Product Change Notification

PCN Number : PCN078

Product Category : DIP Switches – Design Change.

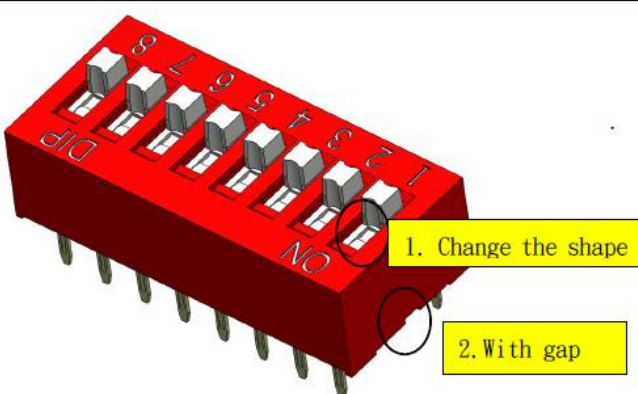
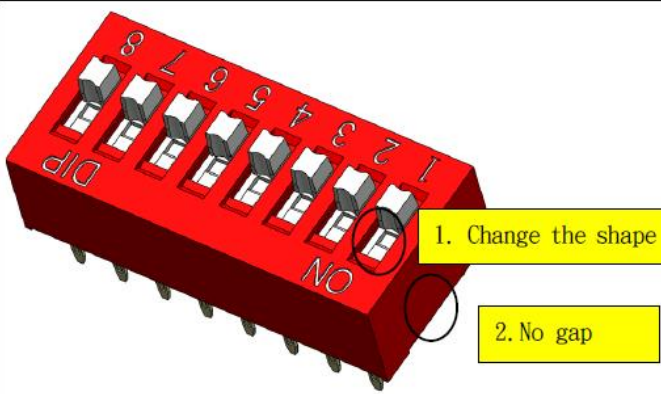
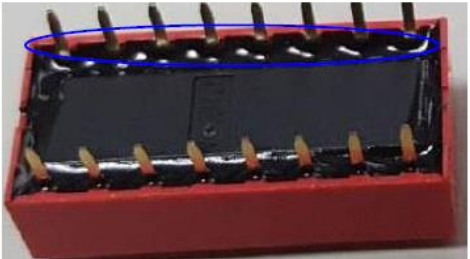
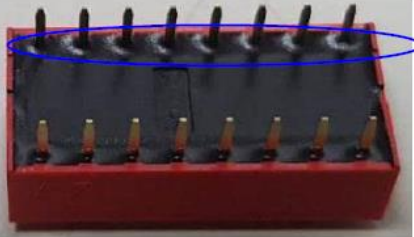
- Change in shape of actuator.
- Change to no clip gap from each side of cover to avoid Glue extraction.
- Change in epoxy to matte surface (Enhance production manufacturer).
- Change in thermos-printing to Laser printing (Laser-printing can meet low-halogen requirement).

Before	After
 <p>1. Change the shape</p> <p>2. With gap</p>	 <p>1. Change the shape</p> <p>2. No gap</p>
 <p>3. Polished epoxy</p>	 <p>3. Matte epoxy</p>

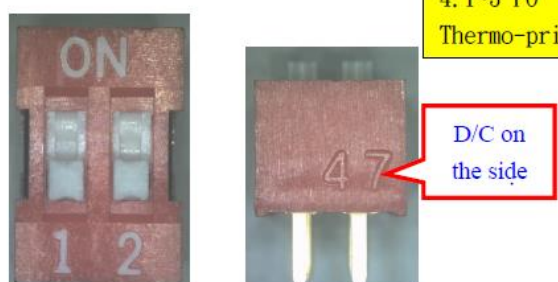
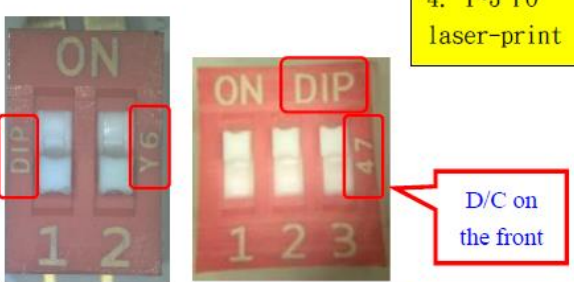
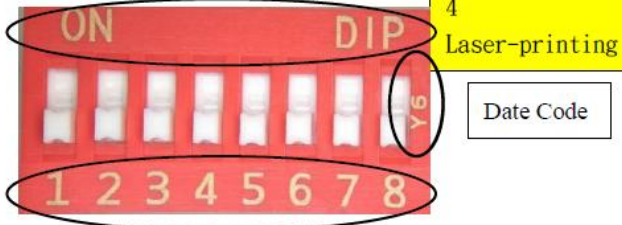
Before	After
 <p>4. 1-3 P0 Thermo-printing</p> <p>D/C on the side</p>	 <p>4. 1-3 P0 laser-print</p> <p>D/C on the front</p>
 <p>4. Thermo-printing</p>	 <p>4 Laser-printing</p> <p>Date Code</p>
